Access Compliance Report

Public Rights-of-Way

(Curb Ramps)

Intersection ID: 10031207	Main Street: MARLOWE_AV	Cross Street: N/A	Location: S
ADA ID: D3D7295B8EA1	Ramp Type: Perp	Initial Pass/Fail: Fail	Overall Compliance: No
		Severity Score: 10

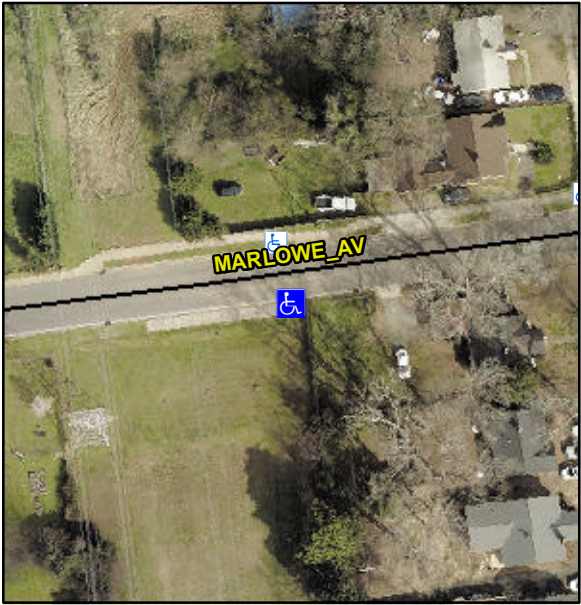
Codes/Mitigation Info/Possible Solution			Field Measurements/Component Compliance			
	Possible Solutions:		Compliance	Description	Data	
	Remove & Replace Entire Ramp.		N/A	Ramp Length (in)	72.5	Yes
			No	Ramp Width (in)	47.5	Yes
			N/A	Flare Type LT	N/A	N/A
			N/A	Flare Slope LT (%)	N/A	N/A
			N/A	Flare Traversable LT?	N/A	N/A
			N/A	Landing Length (in)	N/A	N/A
			N/A	Landing Width (in)	N/A	N/A
			N/A	Landing Slope (%)	N/A	N/A
			N/A	Landing X Slope (%)	N/A	N/A
			N/A	Landing Curb? (Y/N)	N/A	N/A
			N/A	Shared Landing?	N/A	
			N/A	Gutter Ponding?	N/A	N/A
			N/A	Gutter Lip Ht (in)	N/A	N/A
			N/A	Painted X Walk1?	No	N/A
				X Walk 1 Direction	To N	N/A
			N/A	X Walk 1 Width (in)	N/A	N/A
				X Walk 1 Slope (%)	2.3	N/A
				X Walk 1 X Slope (%)	4.6	N/A
			N/A	Ramp inside XWalk1?	N/A	N/A
<p>Surveyor Notes:</p> <p>N/A</p> <p>PROW/ADA:</p> <p>Not Found, R304.5.1</p>			N/A	Road Slope (%)	N/A	N/A
			N/A	Road X Slope (%)	N/A	N/A

N/A	Any Obstructions?	N/A	N/A
				Obstruction Type		
					N/A	N/A
			Yes	Surface Condition? (G/P)	Good	
Total Cost:		\$ 1850.00
